SECOND REVIEW
WC³ Project #: 217-534-003
SLCO Project#: 180695

Subject: Brighton Recovery Bldg. D – Plan Review Comments 2nd Review

Project Name: Brighton Recovery Bldg. D

A4. Sheet A4.2A: Please address the following:

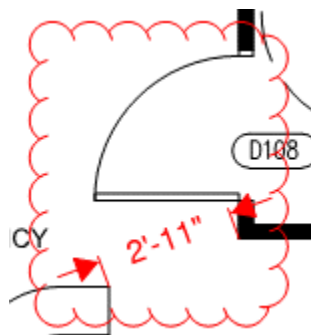
B. Identify on the plans the dimensions of the accessible toilet compartments as required by ICC A117.1-09 604.9. Per ICC A117.1-09 604.9.3 toilet compartment doors shall not swing into the required minimum area of the compartment.

PC2: *The comment regarding door swing is regarding the toilet compartment, not the entrance into the toilet room. Based on the change made to Door D108, it conflicts with passage from the reception/office area when the door is open. Please address.*
